Planning Report Comments	Responses
<p>I should note the Office of Environment and Heritage (OEH) granted concurrence to the proposed subdivision.</p> <p>6.1.2 Drainage Easements</p>	<p>The Hunter Central Rivers CMA Aboriginal officer, Geotechnical assessment has shown the 20 m setback buffer will prevent any impact from subdivision works. The buffer ensures the requirement to protect items under the NPW Act 1974, OEH has provided its General Terms of Approval to the proposal.</p> <p>The "Butterfly Cave" is now subject to an application to have the site declared an Aboriginal Place under the NPW Act 1974. The Applicant has had regular contact with OEH Sydney in regard to the nomination. The advice from OEH was that there was no conflict under the NPW Act between the proposed subdivision, the proposed 20 metre setback and the nomination as an Aboriginal Place.</p> <p>There are no statutory or planning issues to resolve, via this DA, in respect of Aboriginal Heritage.</p>

MOIR LANDSCAPE ARCHITECTURE - DETAILED ADDITIONAL COMMENT ON THE MATTERS RELATING TO  
VISUAL IMPACT.

**Re: Subdivision of Lot 103 & Lot 105 West Wallsend  
Response to Planning Report prepared by Moody and Doyle**

**FIGURE 1**

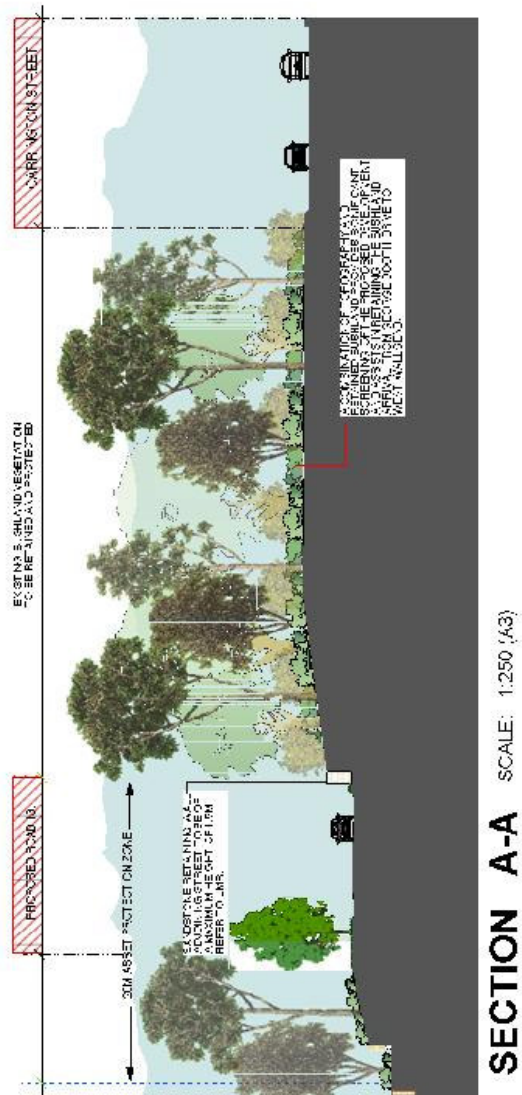
The proposal involves rehabilitation of existing degraded land to screen views to existing houses off Seaham Street, and retention of existing trees between a section of Withers Street and the proposed basin. Combined with extensive landscaping proposed for Basin 1, the proposed street tree planting and the landscaping requirements to the rear of lots where they adjoin Withers Street, the bushland arrival to West Wallsend, although shorter, would be strengthened and enhanced. This is shown, in concept form in Figure 1 and illustrated in Photomontage 1 prepared as part of the LVA.

It can be seen in Figure 1 that the proposed detention basin occurs on land that has been partially cleared of vegetation. A pocket of vegetation parallel to Withers street unaffected by the proposed basin earthworks is proposed to be retained. Refer also Photomontage 1.

Whilst some clearing associated with the basin is likely to have an initial visual impact, the impacts would be mitigated in the short to medium term through proposed landscaping which would ensure the bushland character is maintained in perpetuity. Typically the growth rates of planting within detention basins are rapid owing to a reliable source of nutrient and water.
